Technical Service Bulletin

19J1 UPDATE – 4.0 I Quality Package (NVLW)

October 25, 2013

Model(s)	Year	VIN Range	Vehicle-Specific Equipment
S6, S7, A8, and S8	2013 - 2014	See Campaign/Action screen in ElsaWeb	None

Figure 1. Coolant thermostat (2).

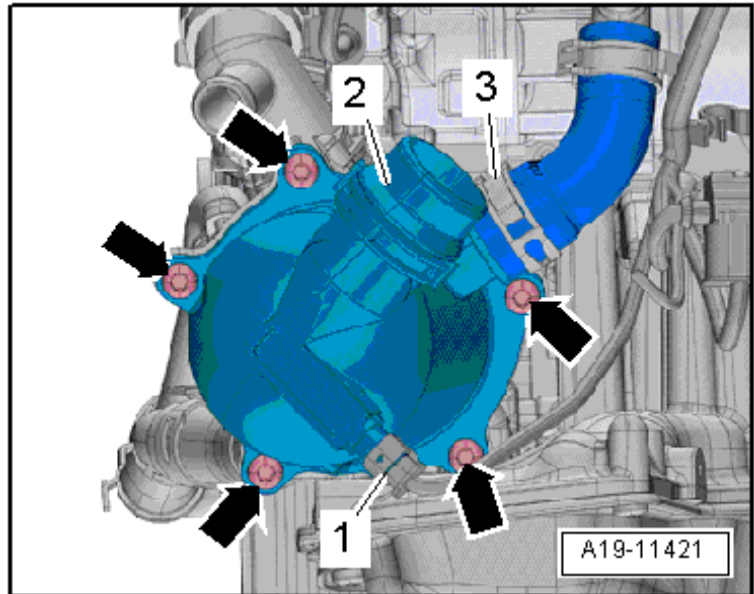
1. Replace the coolant thermostat and the quick release coupling by following the instructions in *ElsaWeb >> Repair Manual >> Engine >> Engine Mechanical >> 19 Cooling System >> Removal and Installation >> Map Controlled Engine Cooling Thermostat -F265-* (Figure 1 and Figure 2).

Figure 2. Quick release coupling (1).

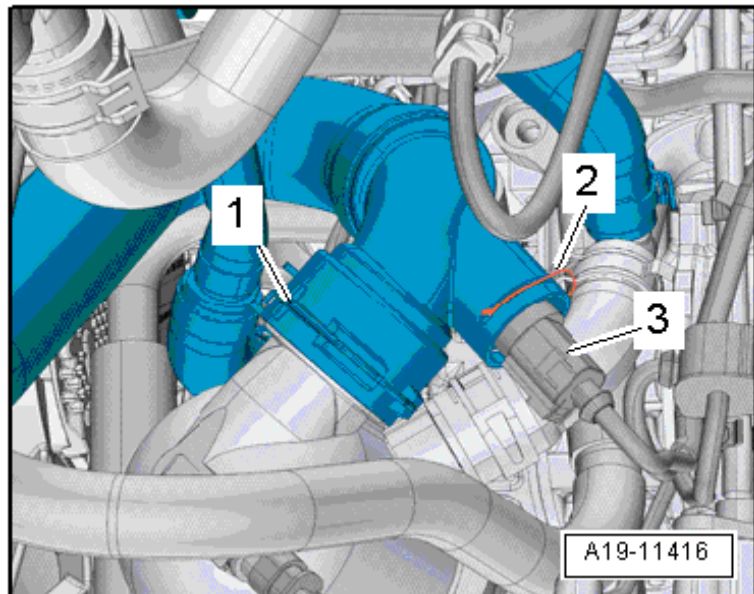
Tip: The quick release coupling is located directly on the coolant thermostat. It is removed together with the coolant thermostat when the coolant thermostat is replaced. However, the coolant thermostat does not have to be removed when the quick release coupling is replaced (Figure 1 and Figure 2).

Figure 3. Closure plate for bumper cover (3).

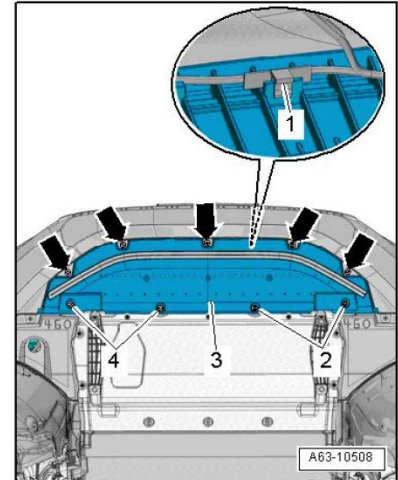
1. Remove closure plate for bumper cover (Figure 3)

Figure 4. Fit protective grille onto radiator.

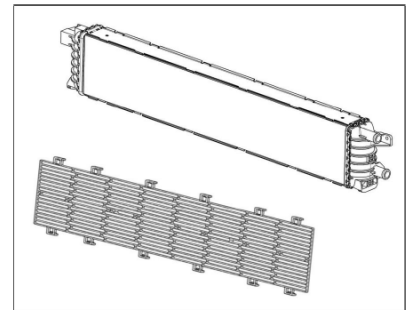
2. Fit protective grille onto radiator (Figure 4) and secure with nine retaining clips (Figure 5).

Figure 6. Location of ACF hose (A).

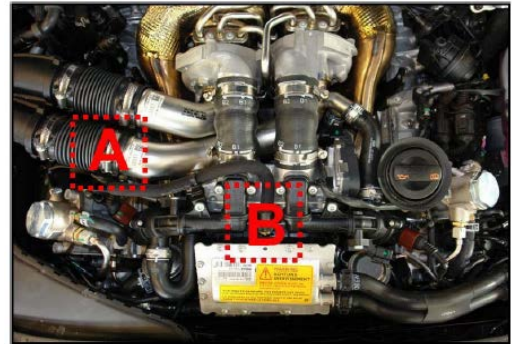
1. Replace ACF hose (Figure 6 and Figure 7). The hose clip can be re-used.

Figure 8. Hose clip (3).

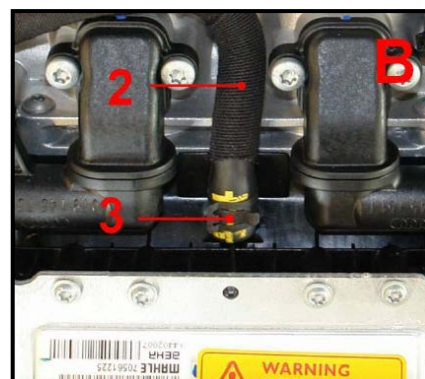
2. Replace hose clip (Figure 8).
